2700 ELLIOTT AVENUE  
**JOSEPH ARNOLD LOFTS**  
DESIGN REVIEW RECOMMENDATION MEETING #2

DPD NO.3009932

JUNE 28, 2011

### INITIAL RECOMMENDATION OF THE DOWNTOWN DESIGN REVIEW BOARD

## Elliott Avenue Elevation “Reconciliation”

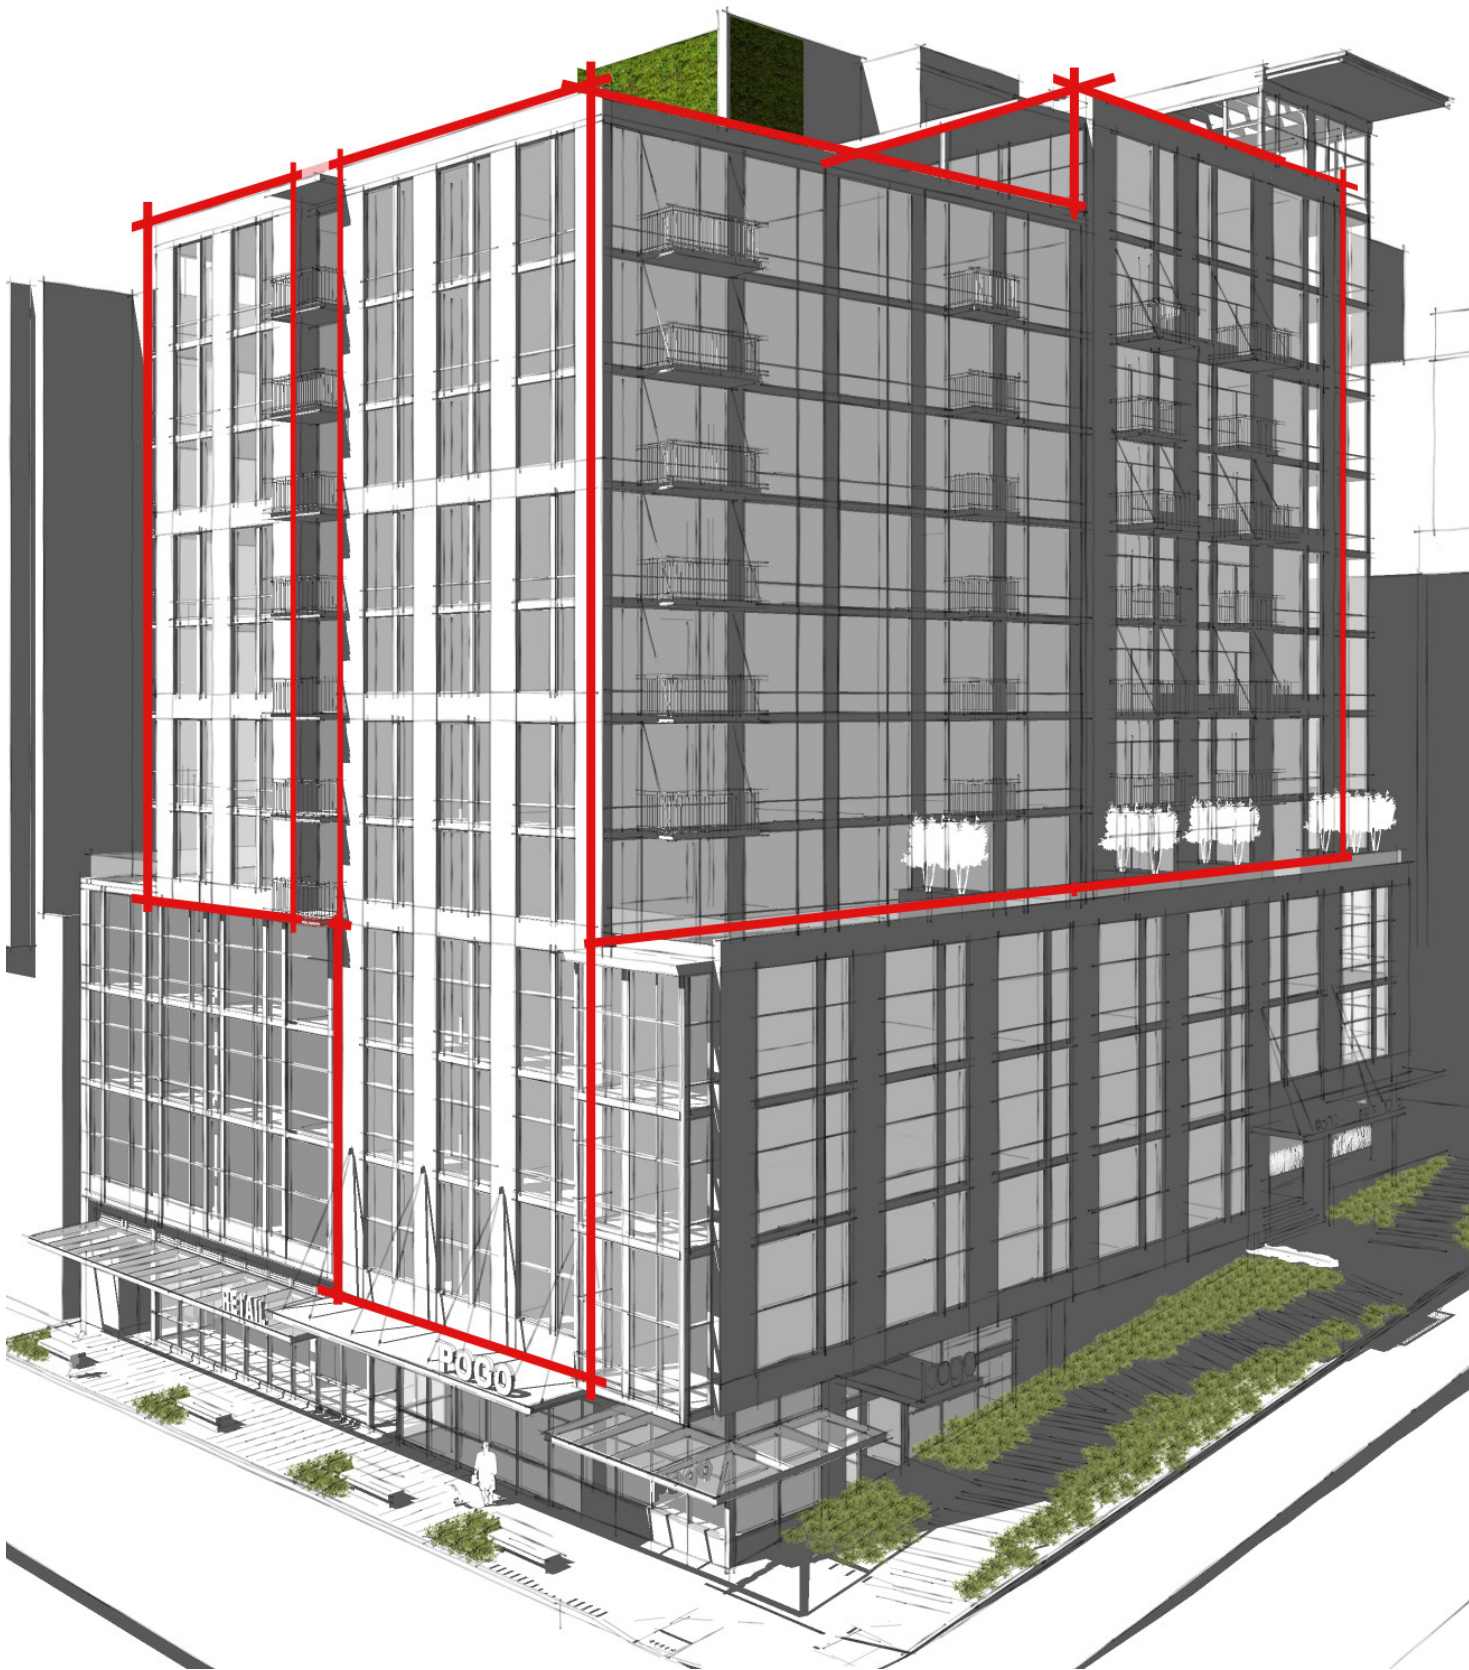
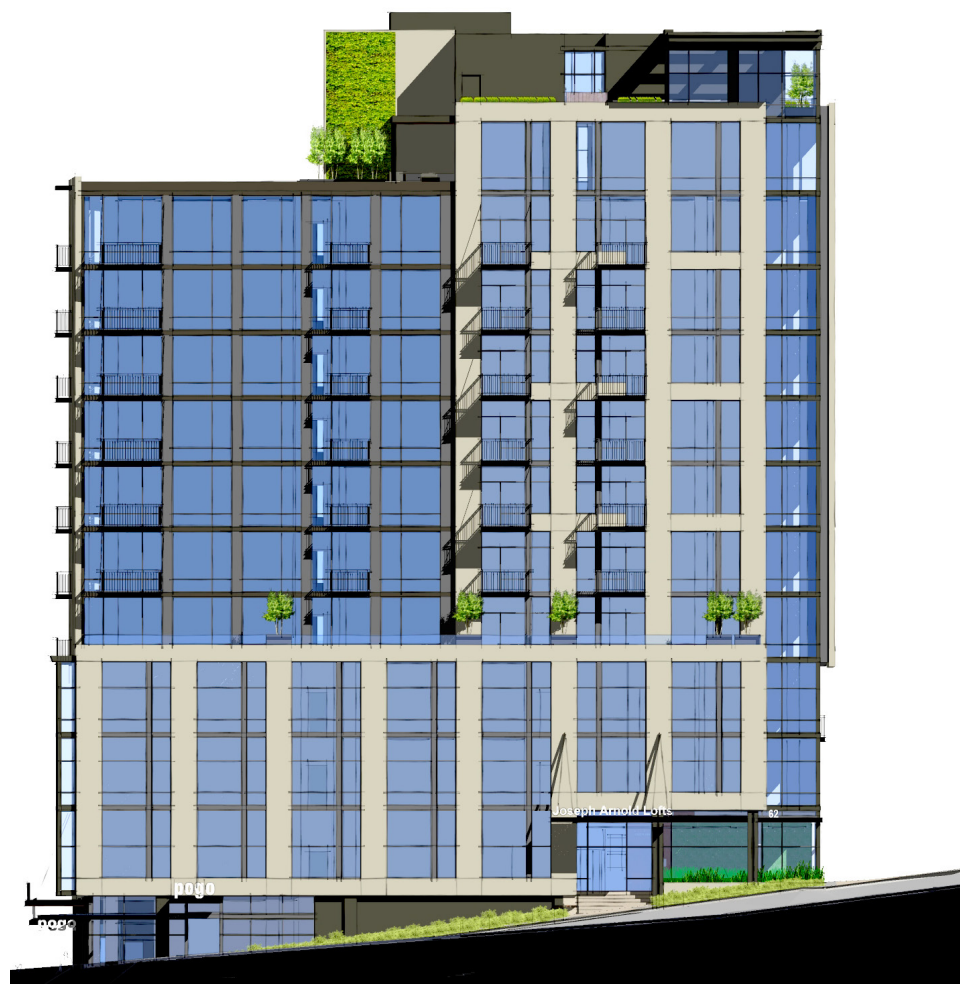
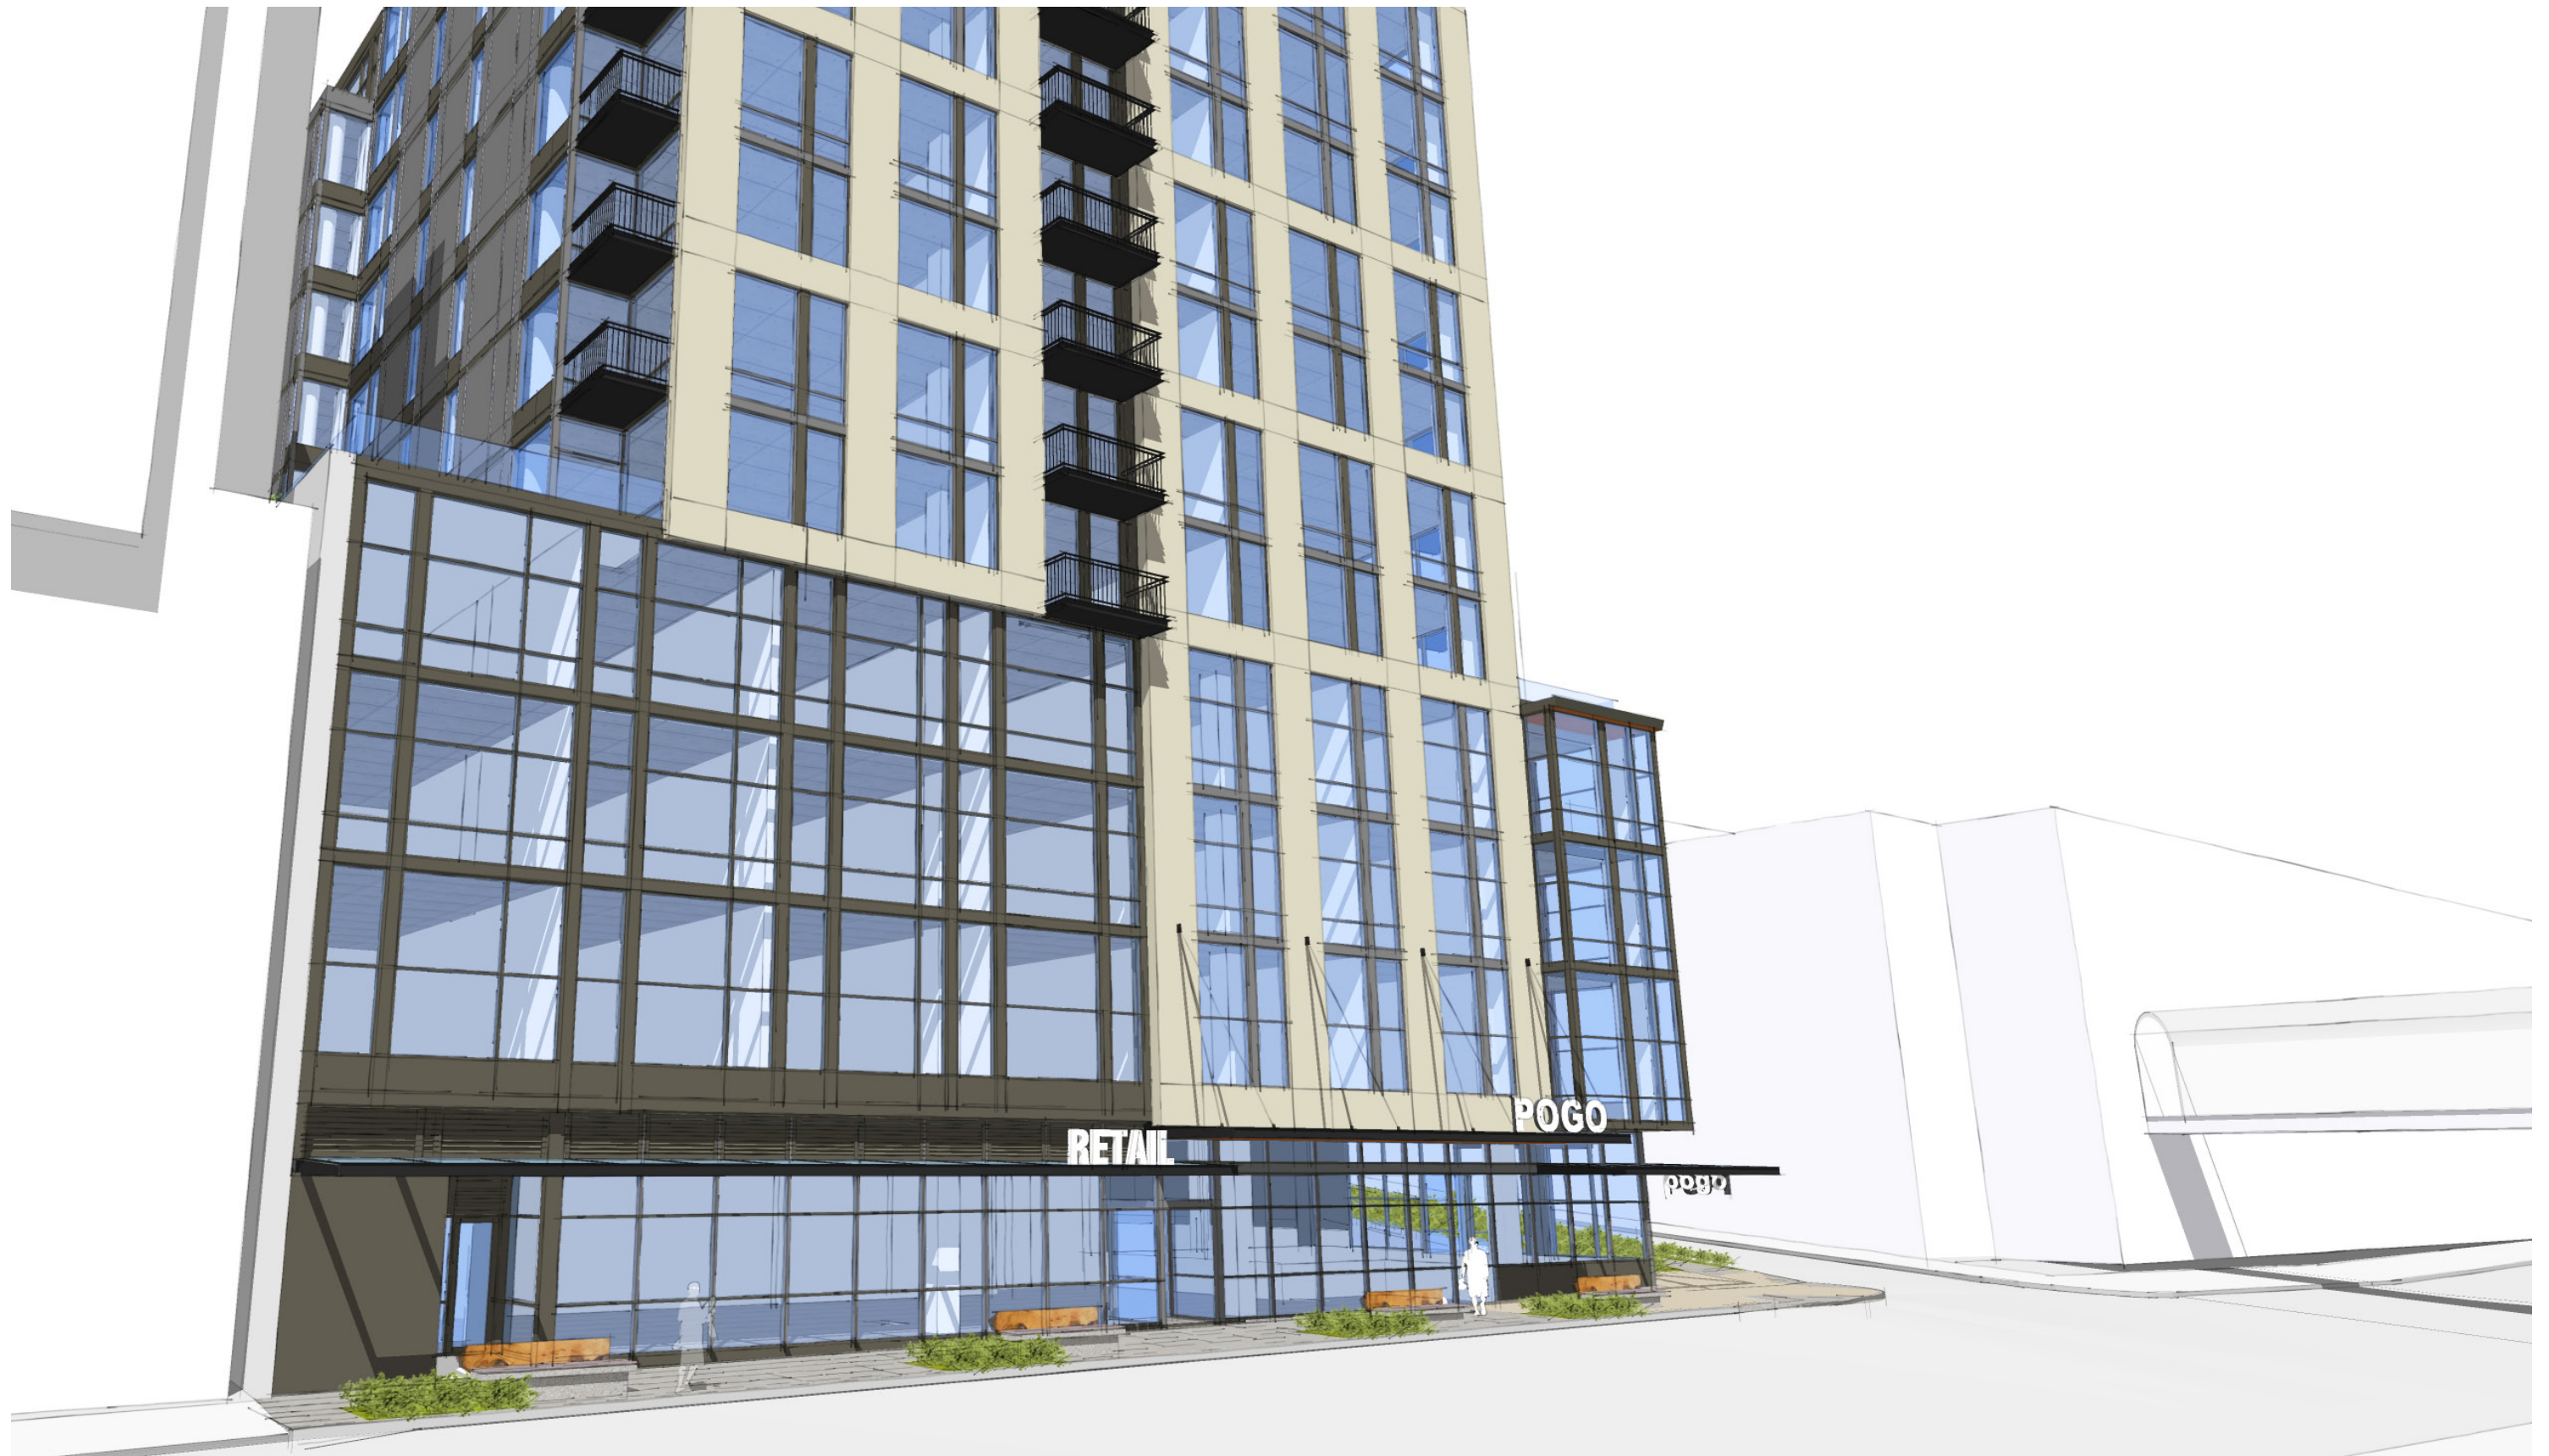
The Board observed that the Cedar St. façade was successful and requested that the Elliott Ave. façade be further designed to reflect and relate better to the one on Cedar St. The Cedar St. façade has a “frame” expressing a base which should be more closely approximated on Elliott Ave. It stated that Cedar St. façade “wants to” wrap around the corner. And while the sharp angularity of the bay window element is OK, it needs to be deeper to be more obvious.

Although we acknowledge the DRB’s request to echo the Cedar Street frame base along Elliott, our approach considers the frames’ impact on the light and window area available to the units along Elliott and the building’s use of the frames as “two-dimensional” objects -- representing discontinuous planes rather than solids.

The west elevation has been simplified and revised to improve the diagrammatic clarity of the base -- as a primarily glass box who’s principal mullions “weave” into and behind the concrete frames above and along Cedar.

The 7'-0" h. window mullions within the "tower" portion of the building have been deleted in this current proposal. This consideration reinforces a subtle but effective distinction between the "tower" and base elements.
